POWER PLANT - ENGINE - EEC HARNESS FAN - LOOMS A AND B WITH SHORTENED FIRE DETECTION LIMBS AND REVISED CLIPPING - CATEGORY CODE 6 - MOD.ENG-71-0154

V2500-ENG-71-0154

## SERVICE BULLETIN

Fig.1

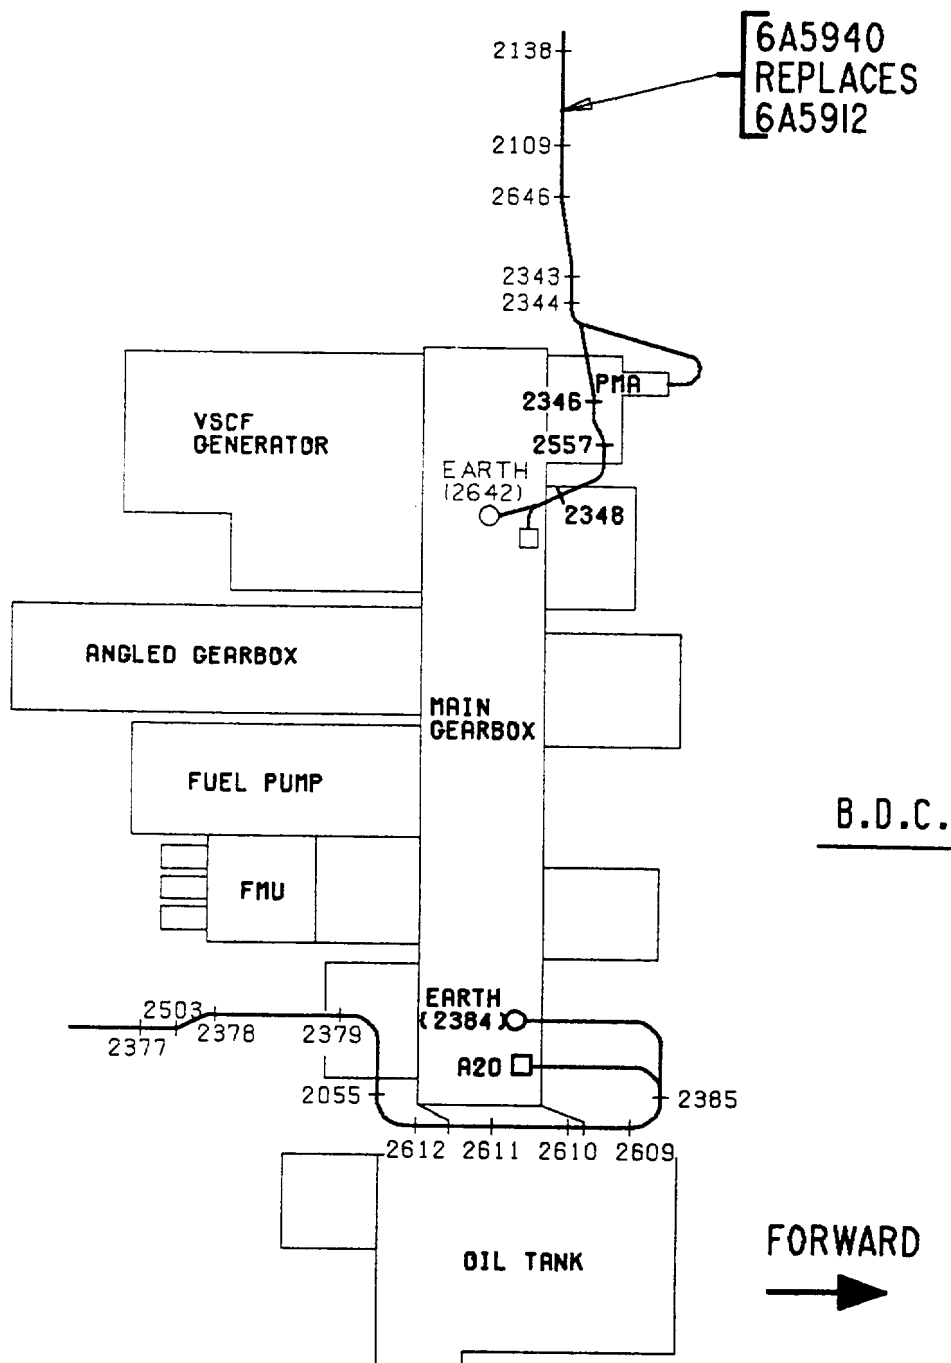
During installation of the EEC Fan Harness, it was highlighted that the length of harness looms A and B fire detection limbs, A20 and B19 were too long and may cause chafing. It was also noted that the revision to four clipping points would improve the harness run and ease installation.

- (c) Revised clipping points CP2346, CP2348 and CP2557 with harnesses loom A and B transposed.

- (7) Assemble clippings points 2346, 2348 and 2557 with the loom 'A' and loom 'B' harnesses, moved into the opposite clips using the existing material from step (2). Torque the bolts to 36 to 45 lbfin (4 to 5Nm), Refer to Figures 1,2,4,5 and 7.

Part schematic view of harness loom 'B' showing clipping points affected - Before and after alteration  
Fig.2

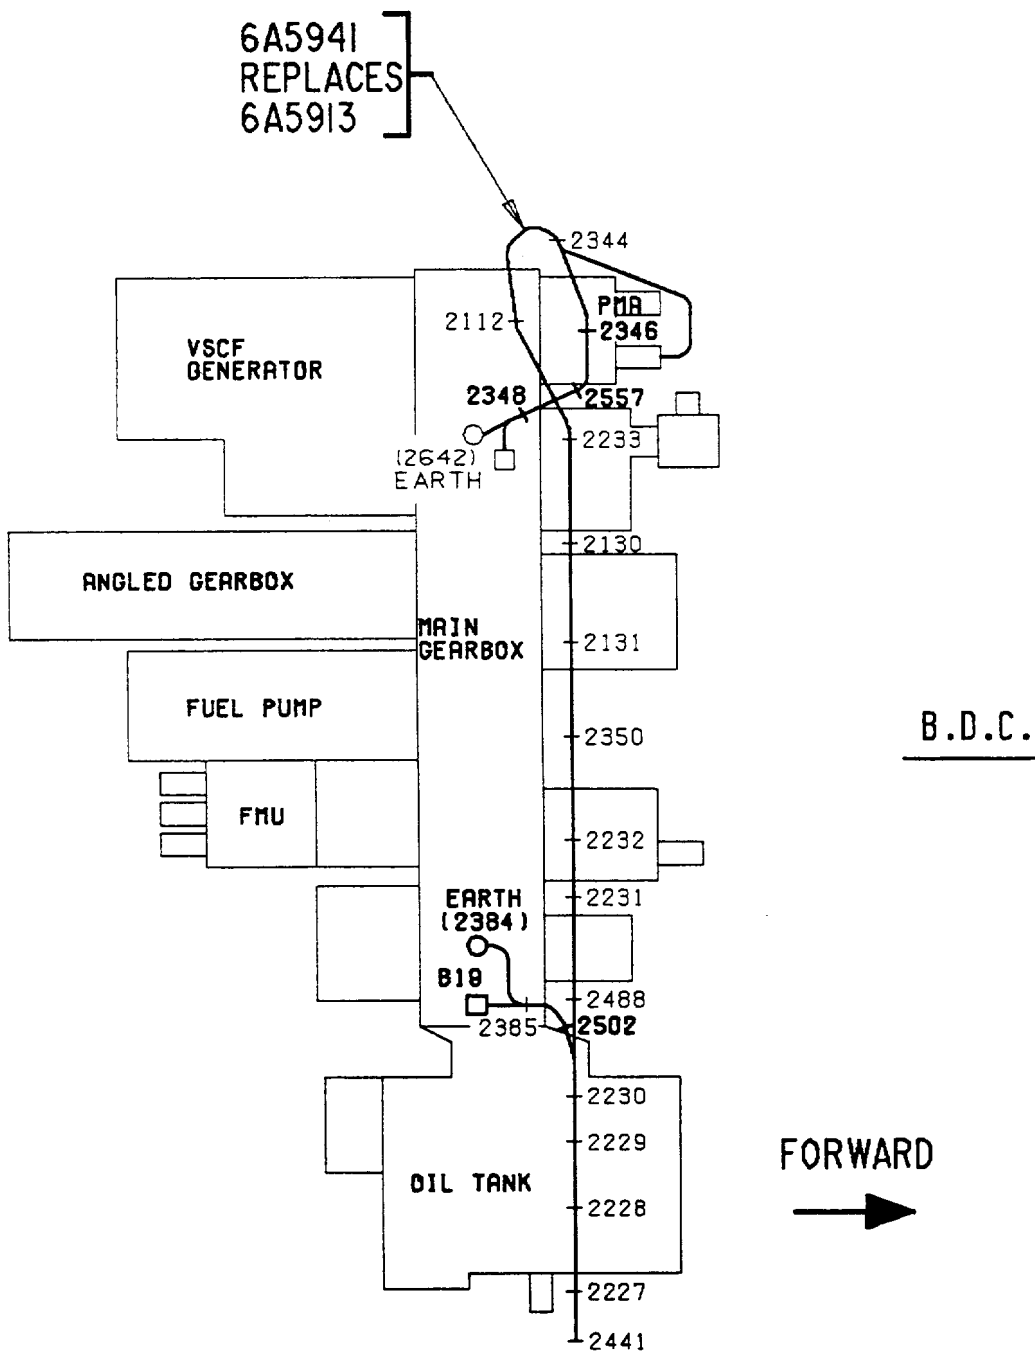
Revised clipping point CP2502 with the clamp re-orientated by 180 degrees.

- (8) Assemble clipping point 2502 onto the 6A5941 harness using the existing material from step (2) with the clip turned to 180 degrees. Torque the bolt to 36 to 45 lbfin (4 to 5 Nm). Refer to Figures 2, 3 and 6.

Part view on harness loom 'A' showing required rework  
Fig.8

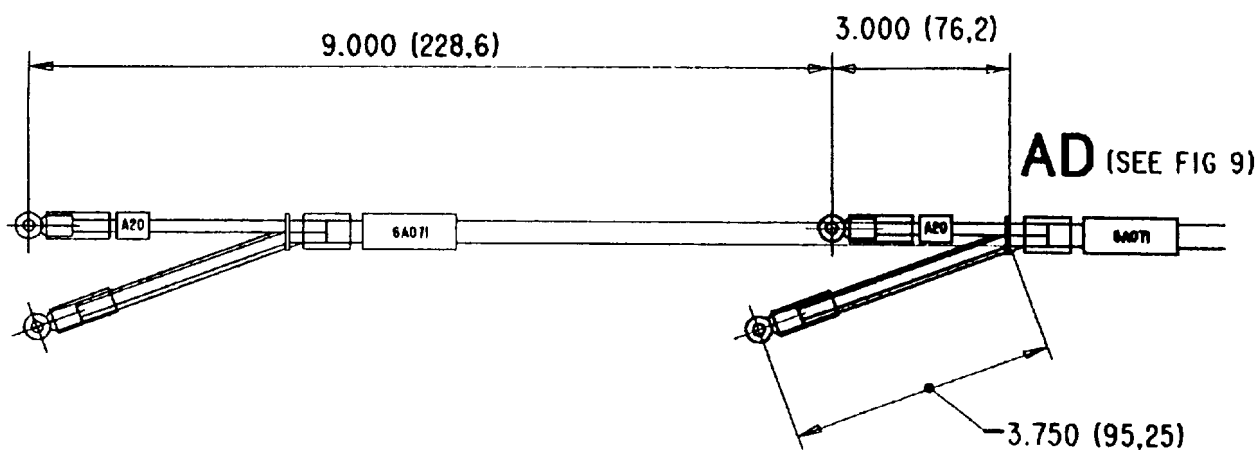
The new harness assembly is identical to the existing harness except for limb A20 being 8.250in. (209,55 mm) shorter with an additional 0.750 in. (19,05 mm) removed from the main wire.

| (a) Cut back existing cable to length shown  | Refer to Figure 8.<br>Use standard workshop equipment.   |
| (e) Again, cut conductor wire to final length.   | Refer to Figure 8.<br>Use standard workshop equipment.   |

Part view on harness loom 'B' showing required rework  
Fig.10

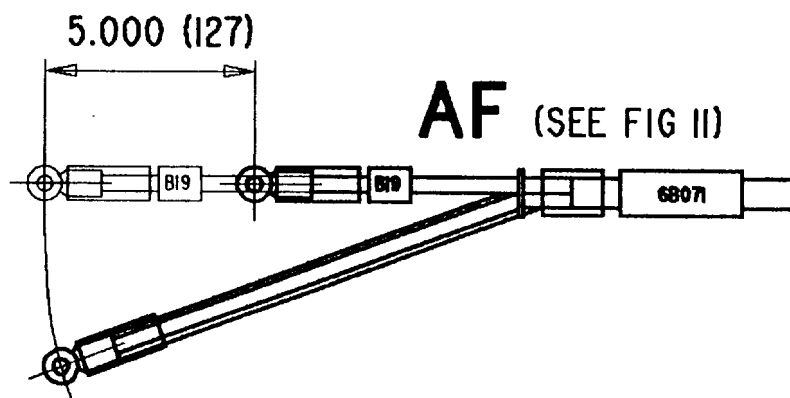
The new harness assembly is identical to the existing harness except for limb B19 main wire being 5.000 in. (1276 mm) shorter.

- (a) Cut back existing cable to length shown.
- Refer to Figure 10.  
Use standard workshop equipment.
- (b) Fit identification sleeve and shrink sleeve tubing to cable.

- Refer to Figure 10.  
Use U32342 or HS064WE sleeving identified B19, 1 off and TFERSIZE1-4 tubing, cut to 0.78 in. (20,00 mm) length.

Rework of existing harness loom 'A' (see Figure 9) showing procedure for fastening lacing tape at harness junction  
Fig.12

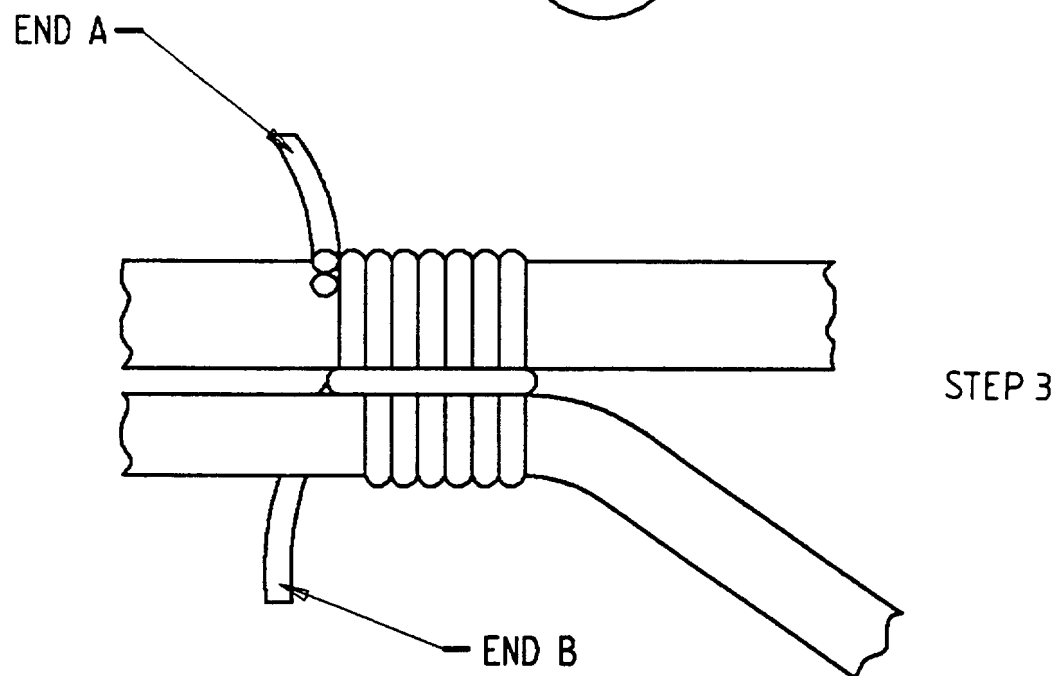
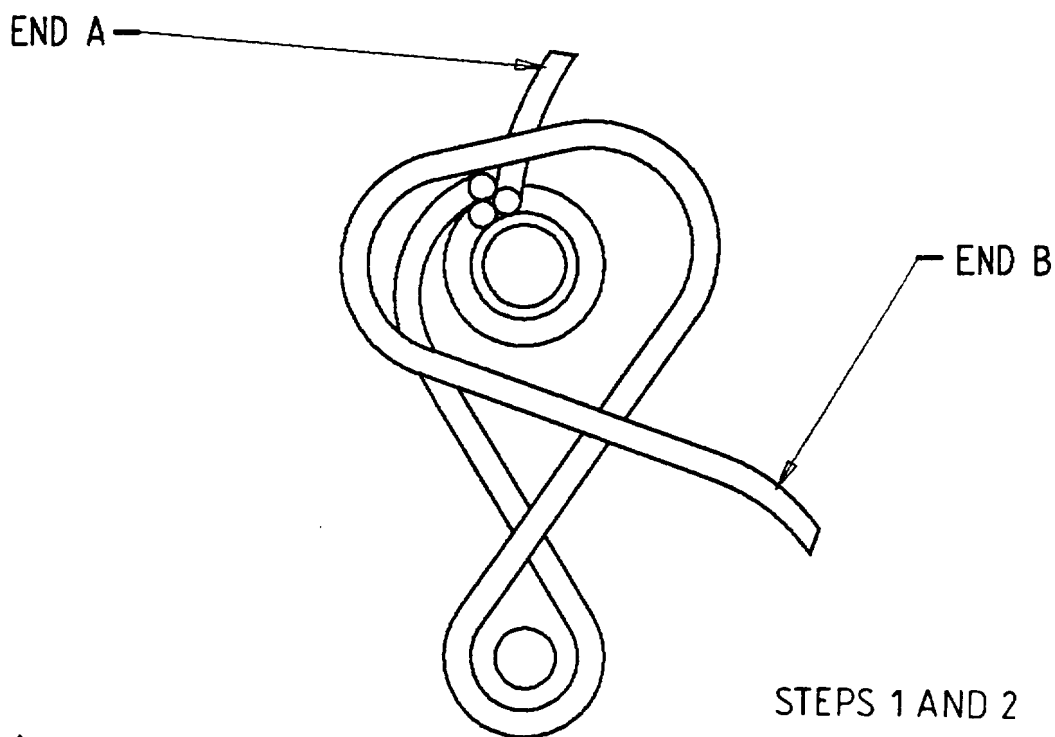
| (f) Tie cable at junction 'AE'.  | Refer to Figures 9 and 12.<br>Use 3100631 lacing tape as required.   |

| (i) Step 1. Thread the lacing tape End 'B' between the conduction wire and pigtail. Wind End 'B' around the conduction wire by a turn and again between the wire and earth pigtail. Pull tight to make a figure-of-eight whip. |  |
| (ii) Step 2. Repeat the procedures in Step 1. six times and pull End 'B' tighty each time.   |  |

- (iii) Step 3. Take End 'B' across the six whippings to the stand point of the lacing and wind tightly around the six whippings between the wire and pigtail by three turns. Attach End 'A' to End 'B' to make a reef knot. Cut-off unnecessary lacing tape at End 'A' and 'B' to minimum length of 0.31 in. (8,00 mm).
